## Addendum 02

**Project:** CATA Bus Depot Renovation

**Project No:** 75820026

#### FIRST FLOOR FINISH PLAN

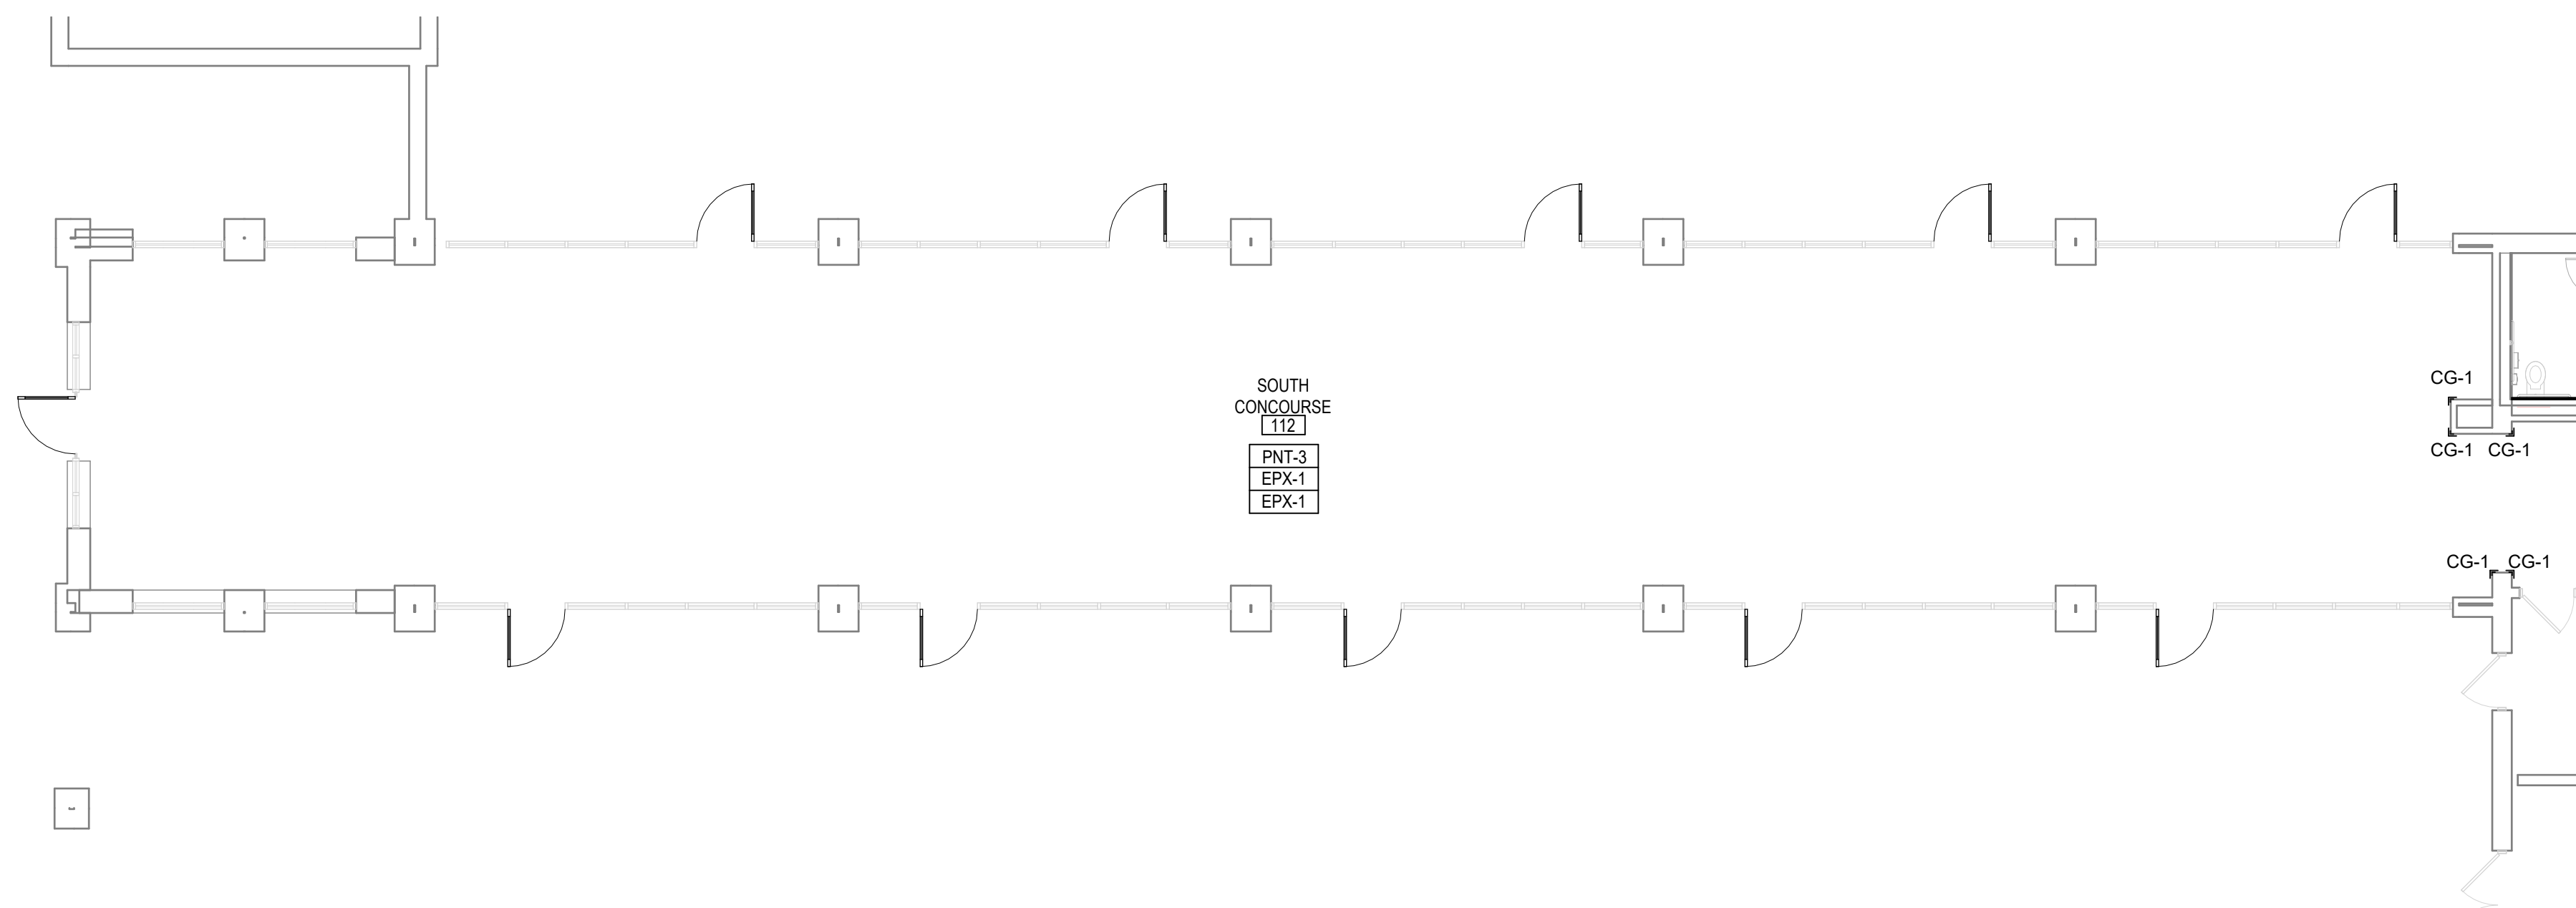
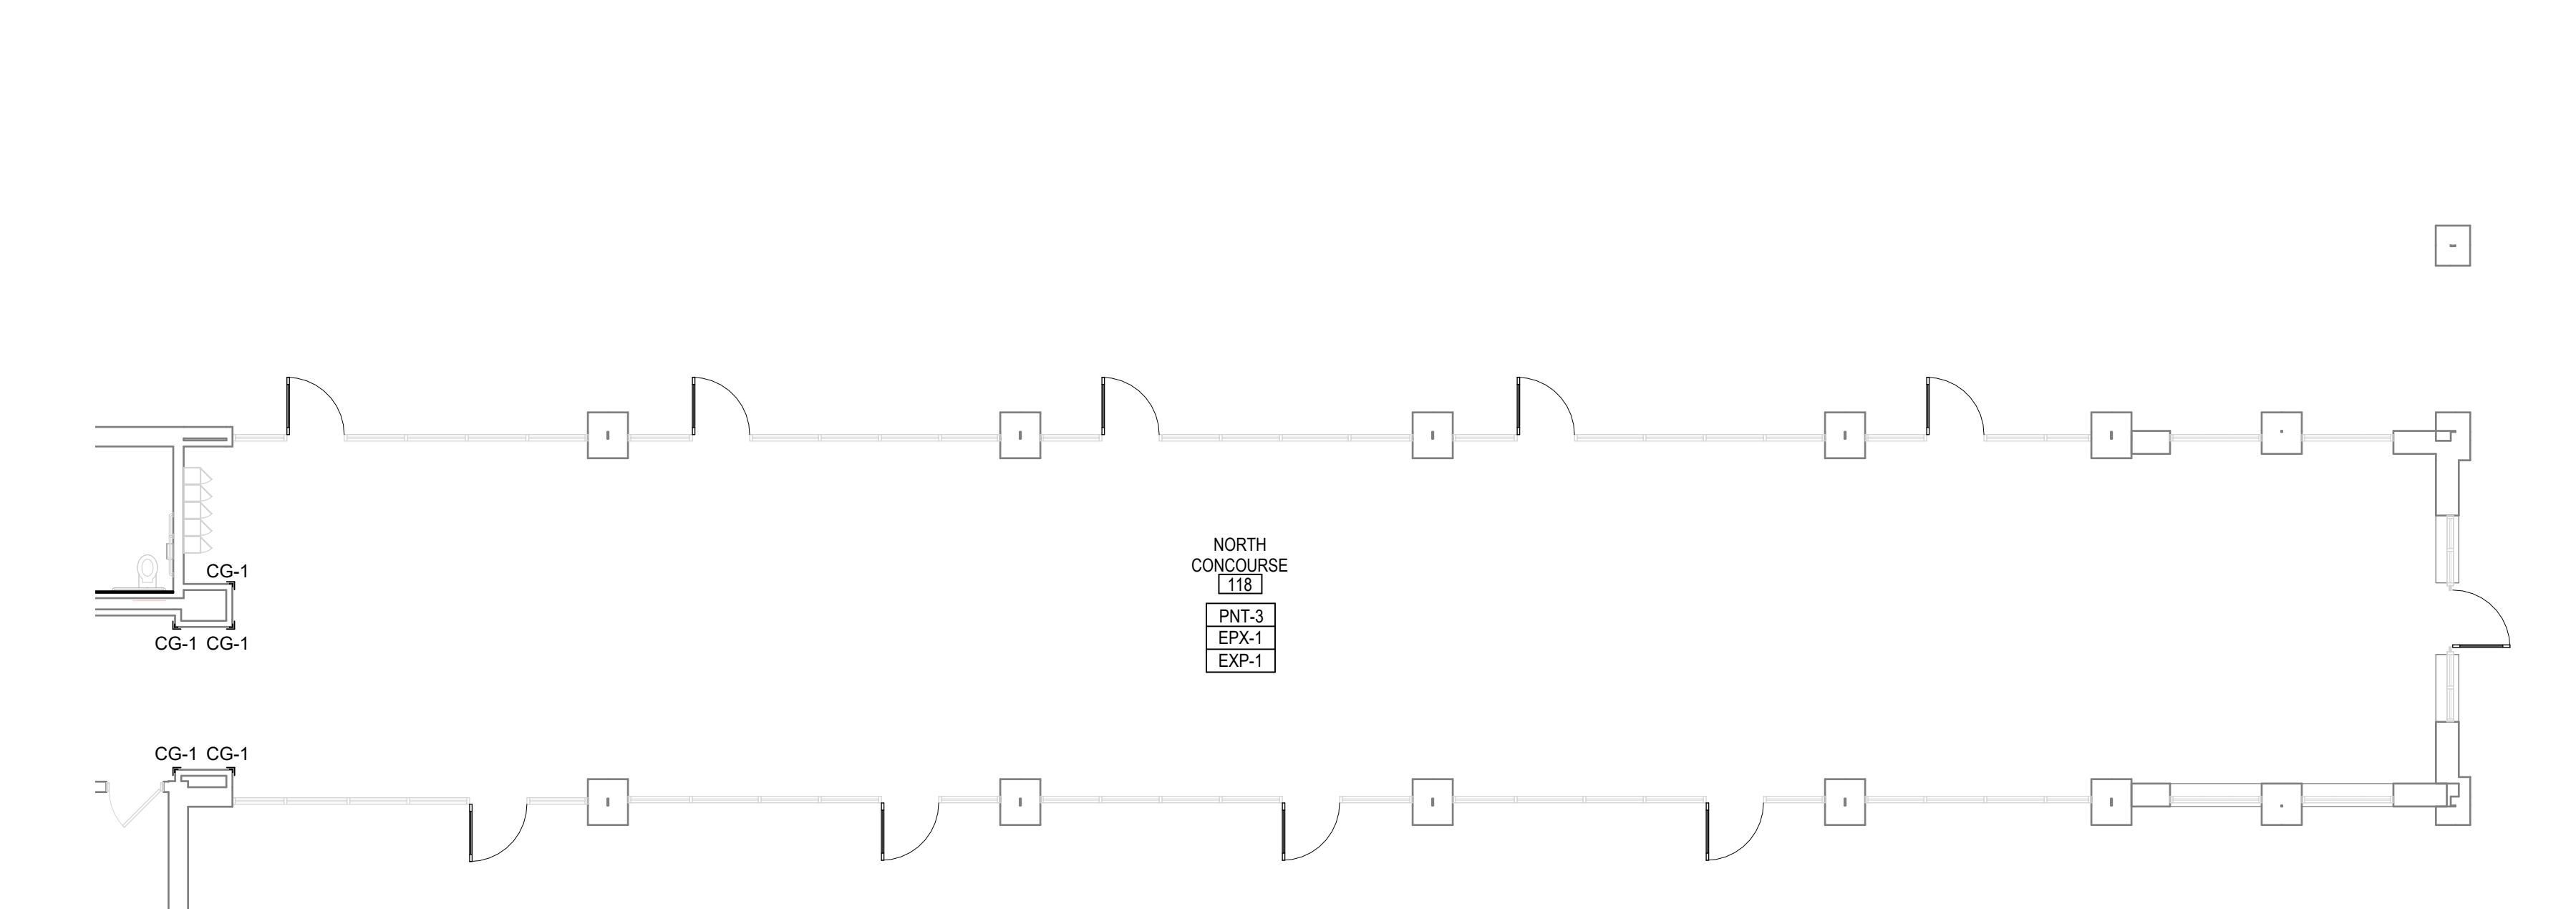
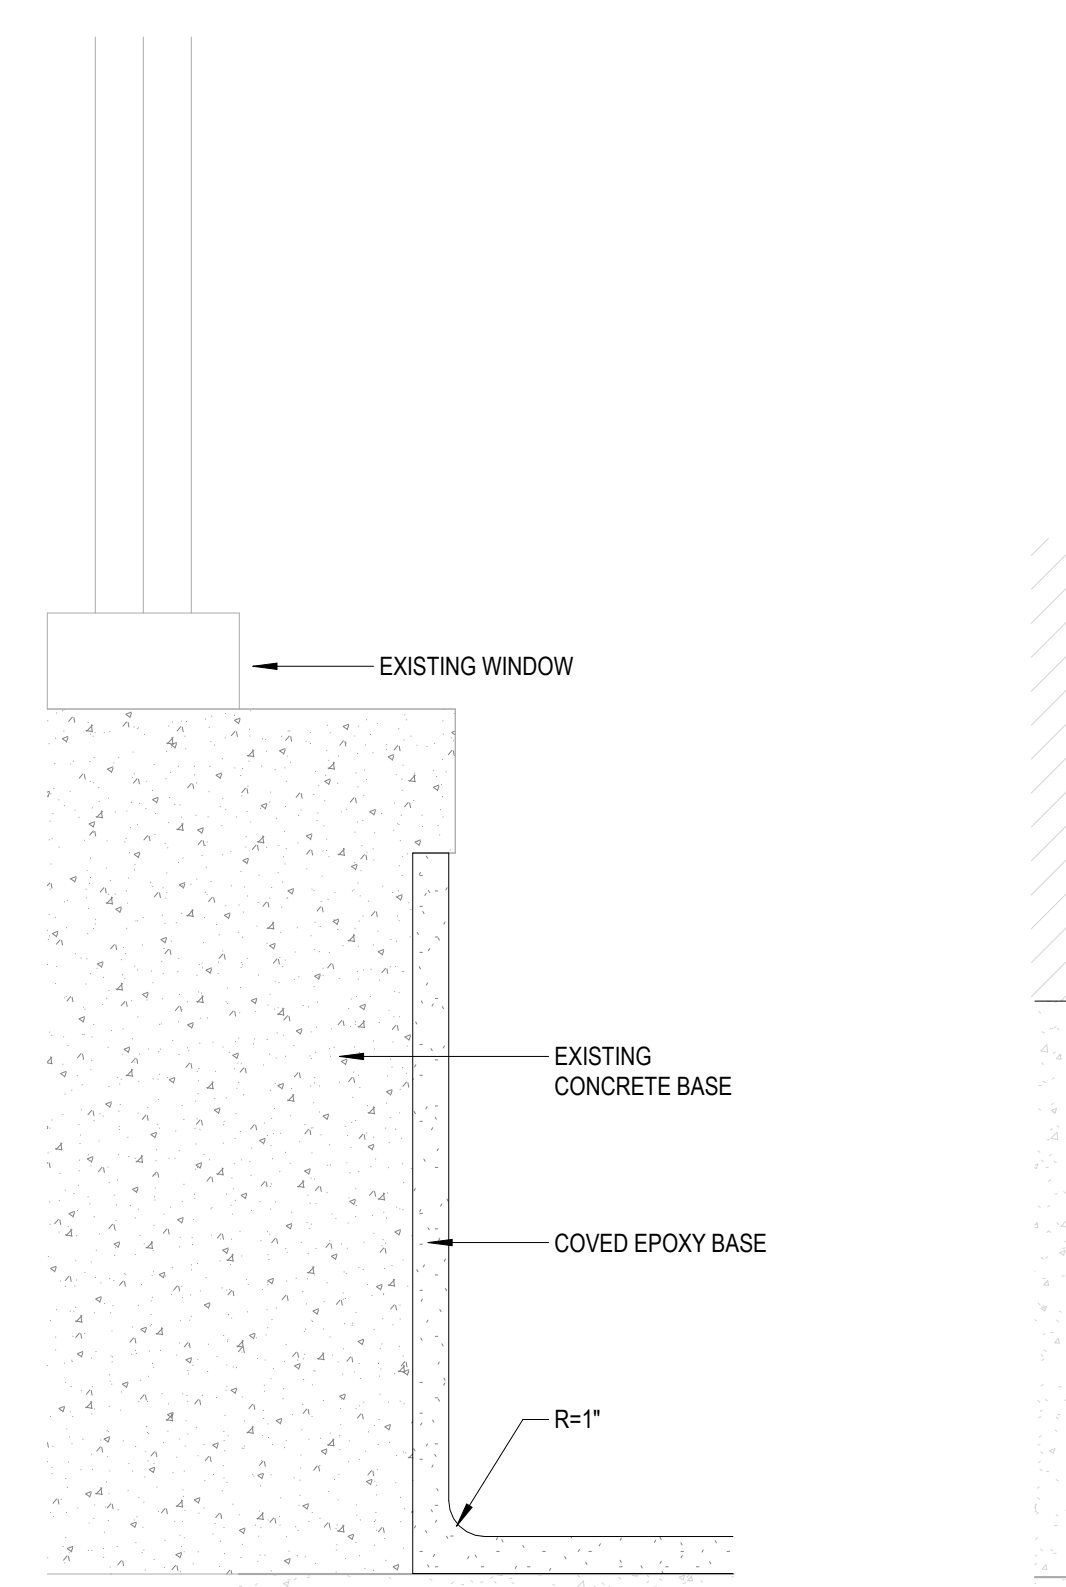
**G. QUESTION RECEIVED:** The plans mention FRP in the Finish Material List, but I do not see it noted in the drawings. Where is the FRP to be installed?

- Contractor parking to be at 511 Washington building during construction.
- Material loading is preferred at south end of facility.
- Resinous floor in main area to continue into Resource Room.
  - Refer to updated A403 Finish Plans & Finish Material List.

**Response:** FRP-1 to be installed at JAN 121C floor sink.

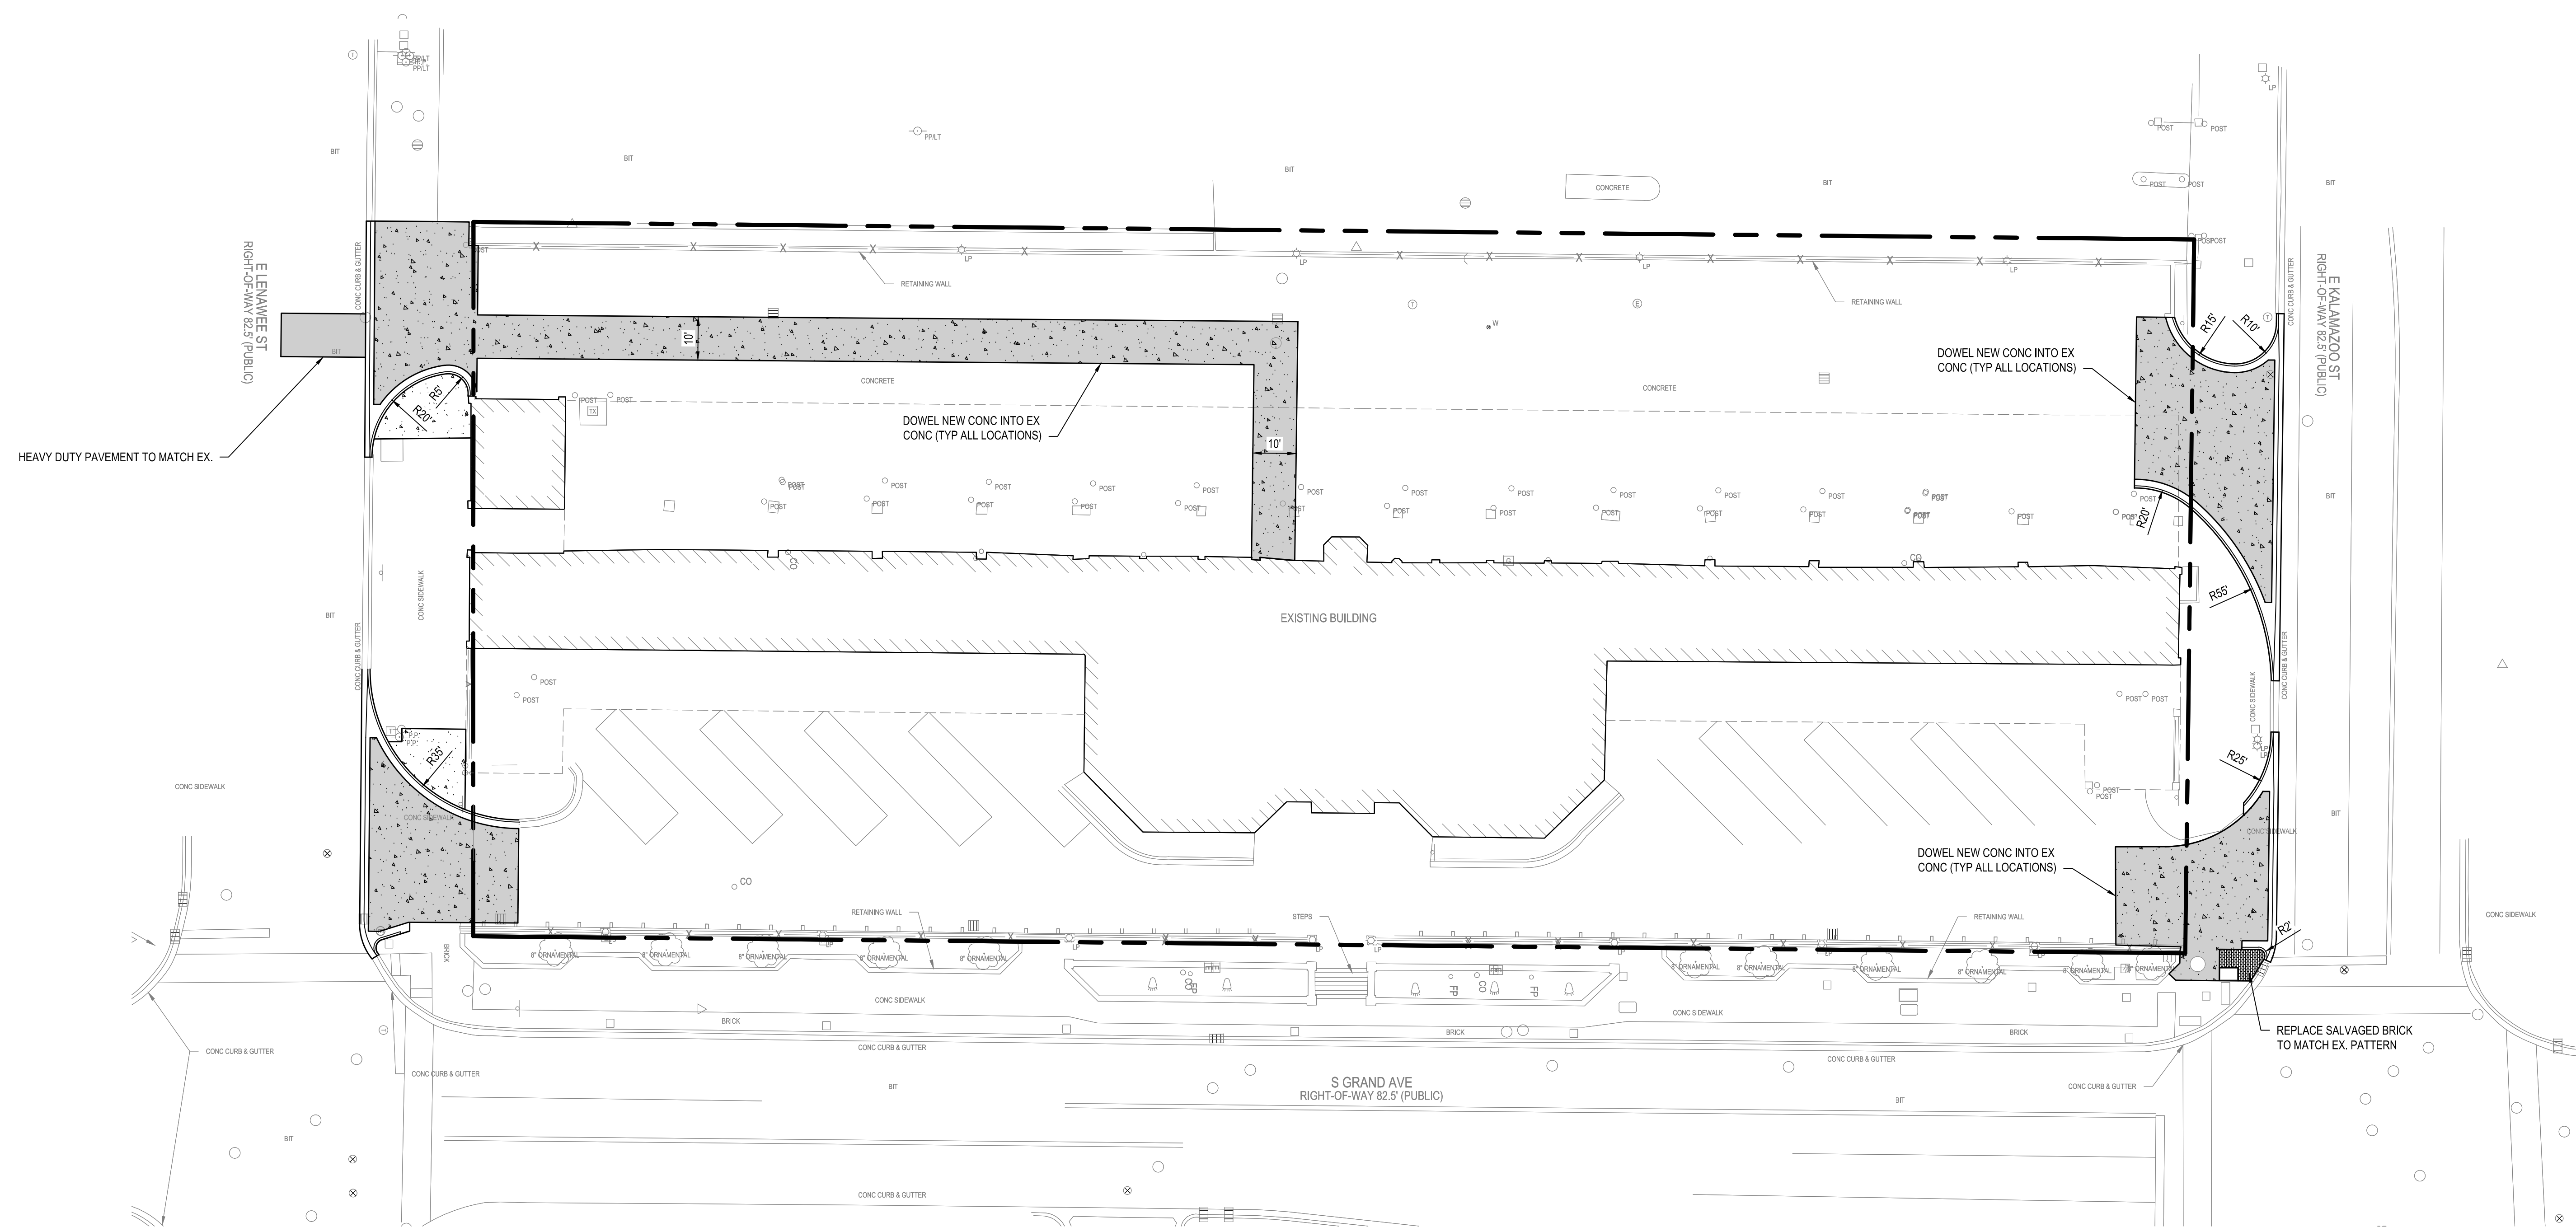
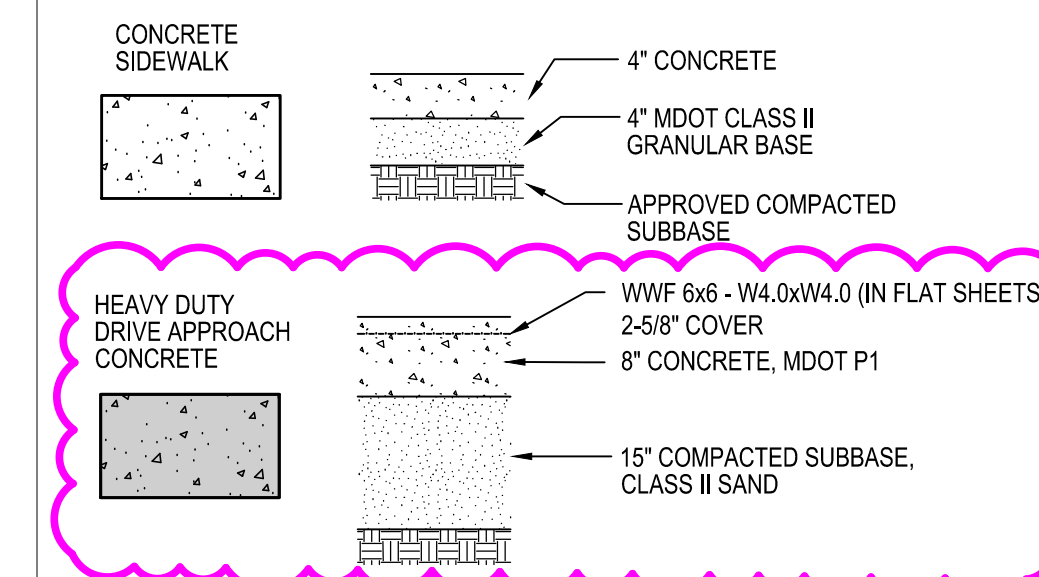
- C. QUESTION RECEIVED:** Are 6" slabs to be reinforced?

**H. QUESTION RECEIVED:** One of our asphalt contractors requested specifications and/or a cross-section of the area to be patched if possible. The drawings say to match existing currently.

**Response:** Yes. Note added to pavement legend. WWF 6x6 – W4.0xW4.0 (in flat sheets).

**Response:** Yes, refer to updated C201 Site Layout Plan-Plan.
